# REGIONAL REVIEW FINDING

ARC REVIEW CODE: R1006011

**Submitting Local Government:** Fulton County  
**Name of Proposal:** Grey Mixed Use

**Review Type:** Development of Regional Impact  
**Date Opened:** Jun 1 2010

### PROPOSED SITE PLAN CONCEPT PLAN FOR GREY MIXED USE DRI 2089

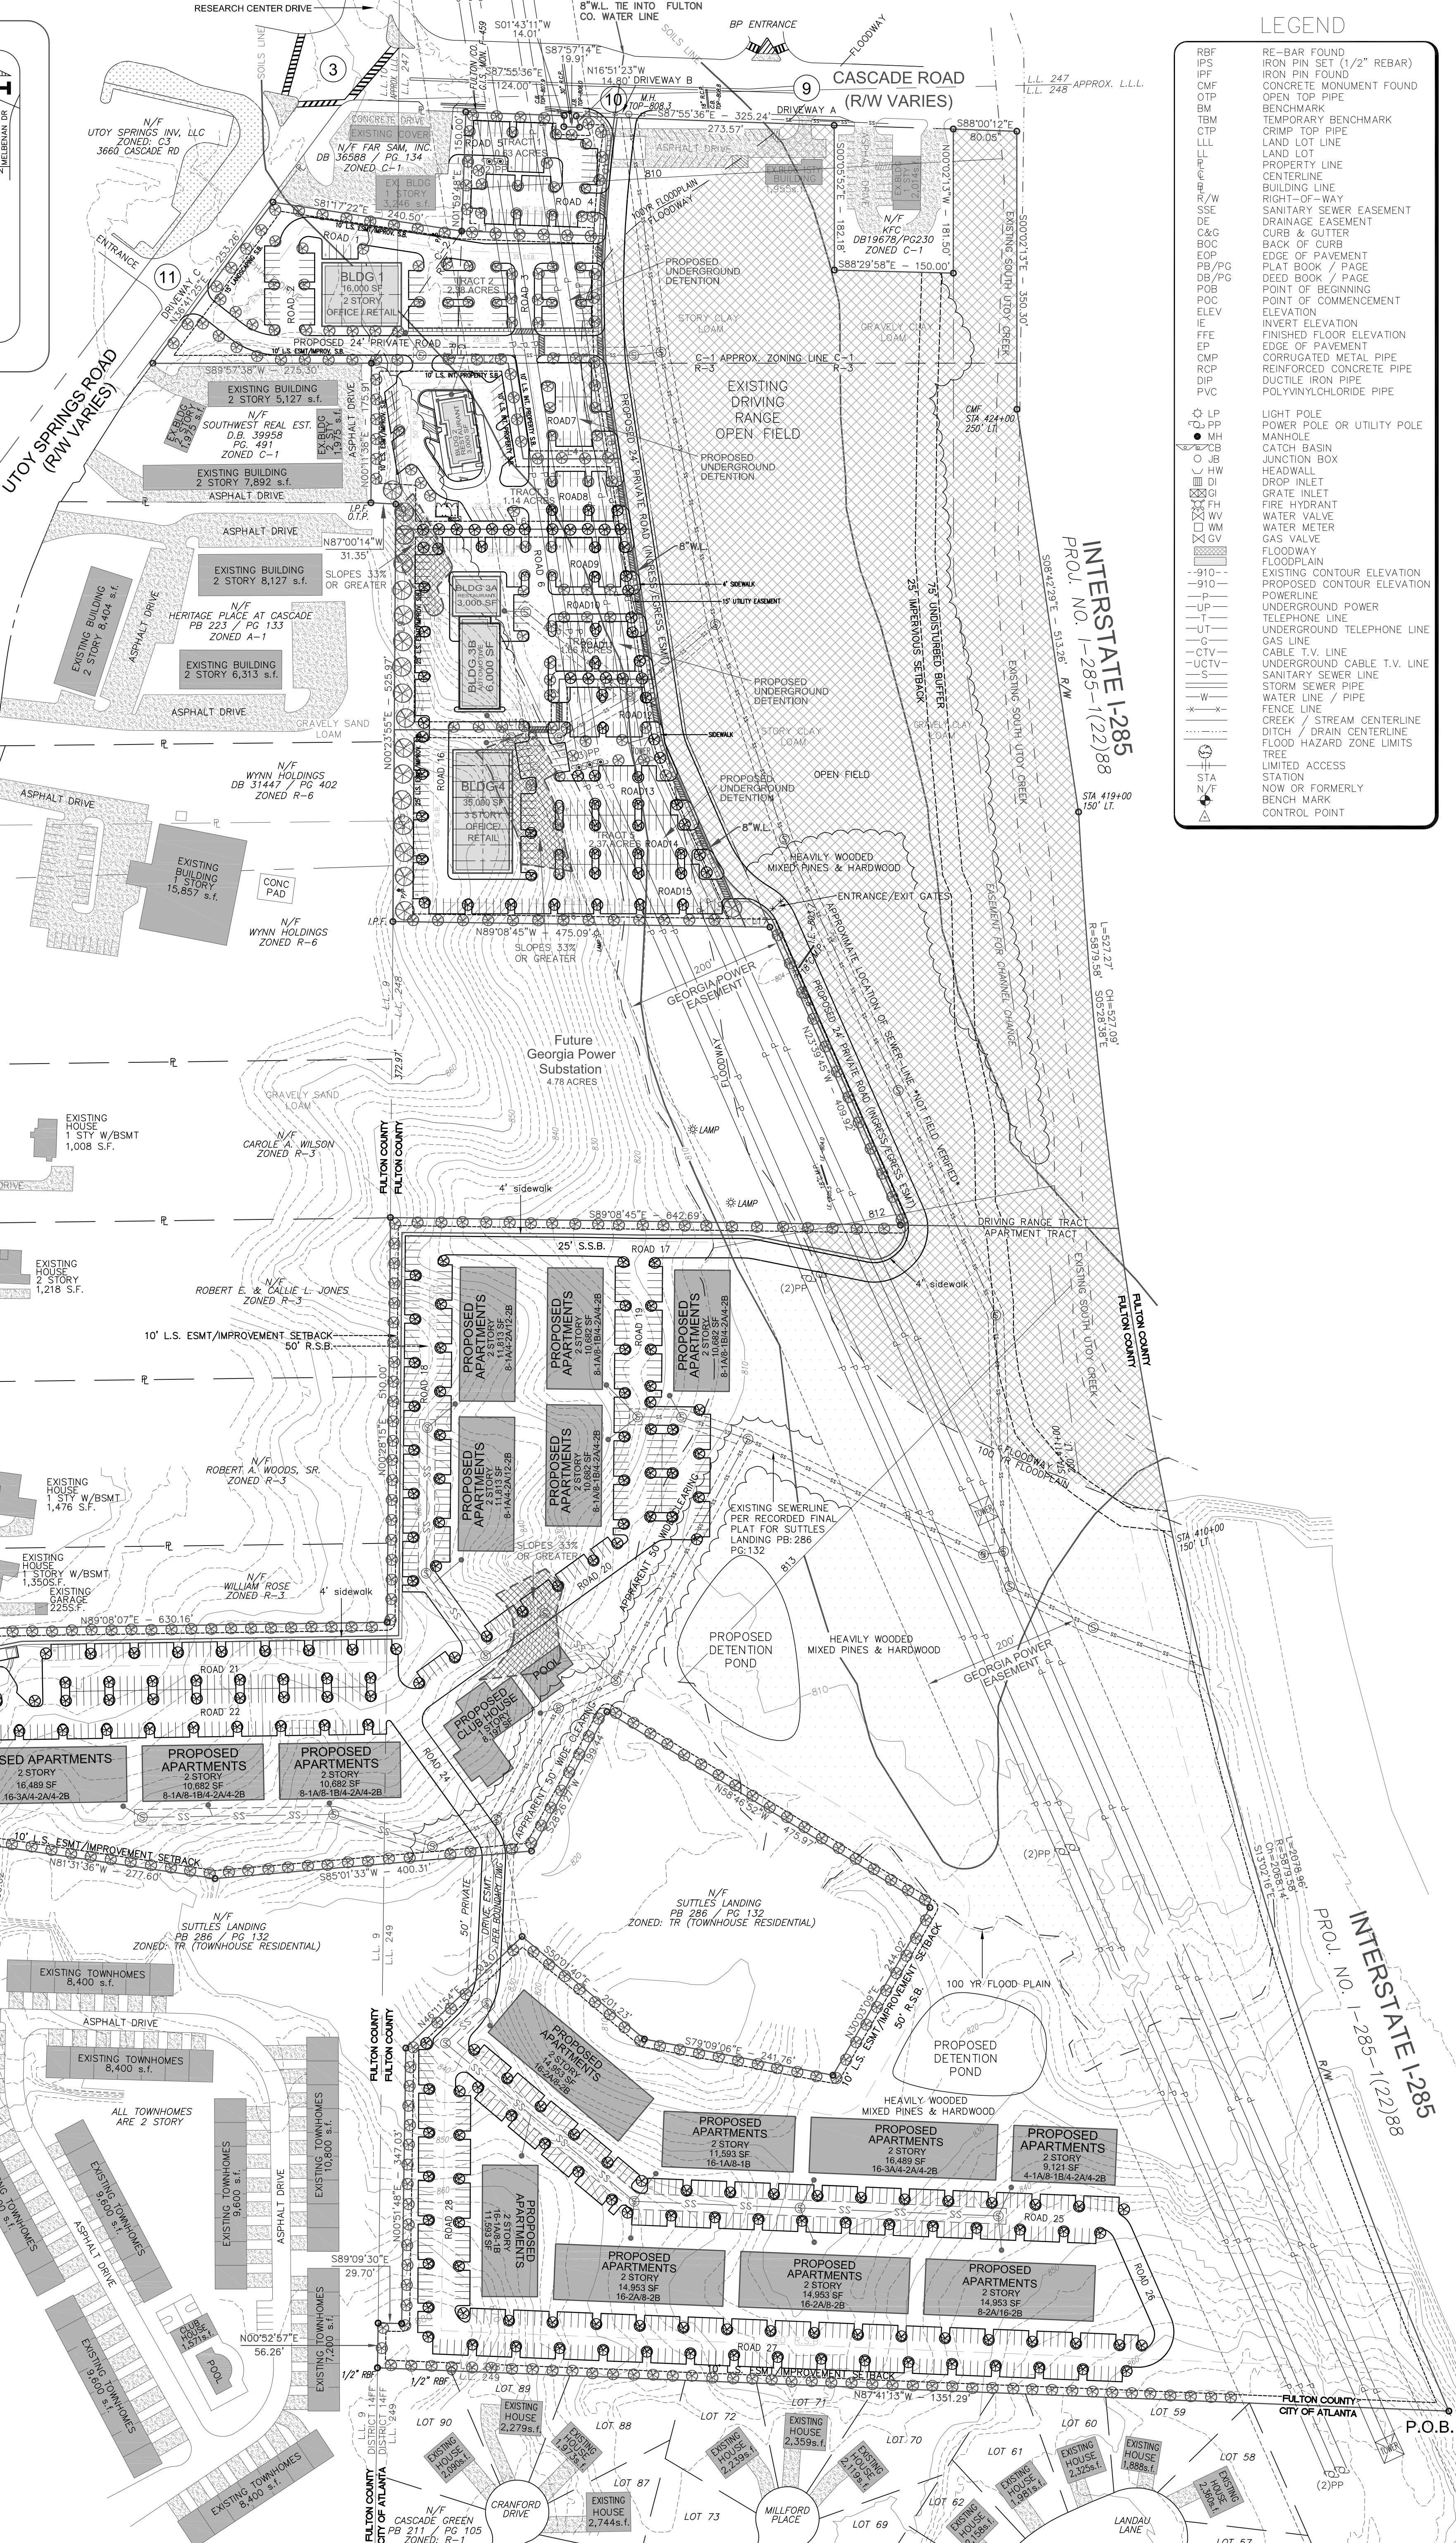
The proposed development will consist of several uses within close proximity of one another. Though the uses are adjacent, they are not mixed. The current shape of the subject property is very disjointed and hampers the ability of the existing development, as well as future developments to connect to one another in a direct and logical way. The presence of the existing power easement and future power substation also present barriers to future connectivity and integration between development sites. Rather than developing the site as if there were no adjoining properties that could develop or redevelop in the future, the proposed development should be planned so that the entire block develops and functions in a more integrated manner.

The developer should provide connections to adjacent properties where possible. The commercial and office portion of the site, tracts 1-5, could be connected to the existing buildings that front onto Utoy Springs Road providing these properties with additional connections to the road network and improving connectivity within the area.

The proposed development is also providing a surplus of parking. As well as reducing the amount of parking to the required amount, the developer should seek to reduce parking even more. This can help to reduce the amount of impervious surface and thus reduce the amount of stormwater runoff. What parking does remain, should be placed behind or to the side of buildings and screened from the nearest public street.

The developer should also consider clustering the residential development in order to place residents closer to retail and commercial services and create additional greenspace. The current site plan shows two story apartments. These could be "stacked" to make four story buildings which would decrease the acreage taken up by the apartments and create additional room for potential greenspace.

- Close Driveway A due to low usage, proximity to the I-285 on-ramps, and Access Management and safety considerations. Instead, provide access to the golf range off the newly constructed Driveway B, ensuring sufficient throat length required for safety

- Provide a road stub-out from Road 17 in westward direction (towards Fairburn Road), at the corner of the parking lot next to Jones’ property, so that in the future, when the single-family residential properties along Fairburn Road redevelop, a new street connection can be created continuing New Halem Street to connect to proposed Road 17.

- Proposed 4 feet wide sidewalk along the proposed private road (roads 21, 18, 17) on the property should be widened to a 5 feet sidewalk or provide a 5x5’ passing zone every 200 feet to be compliant with ADA guidelines (ADAAG and PROWAG).

- Private roadway terminating in Driveway C that connects to Utoy Springs Road does not appear to have sidewalks, based on the plan. Provide sidewalks along both sides, at least 5 feet wide.

- Build sidewalks (at least 5' wide) along both sides of Fairburn Road, from the southern tip of the development, to connect with existing sidewalks on Utoy Road. On the south side, the east side sidewalk should connect with existing sidewalk along the existing townhomes property. While the proposed development does not include all the properties along Fairburn Road, it likely precludes a future large-scale redevelopment along this stretch of Fairburn Road. Therefore, the currently proposed DRI development presents the best opportunity to add the sidewalks along the stretch of the road. Sidewalks are particularly important to allow transit users to access a transit stop.

- All the commercial and office buildings should have access via ADA-compliant sidewalks or pedestrian walkways, so that those are clearly marked and pedestrians can navigate safely through the parking lots. It is not immediately clear from the plan which buildings have pedestrian access and which ones do not. It appears that Buildings 2, 3A and 3B are not well-connected to the sidewalk network. If pedestrians consider it unsafe to approach the building due to the lack of ADA-compliant sidewalks through the parking lot, no alternative mode trip reduction can be claimed.

- While there are currently no bicycle facilities along the corridor, Fairburn Road is indicated as a secondary bike route on Connect Atlanta Plan, with connection to Benjamin Mays core bike route to the north of the site. A 4-ft bikeable shoulder and "share the road" signs should be provided along Fairburn Road, from the southern tip of the proposed development, to Fairburn Road and Utoy Road split at the northern end.
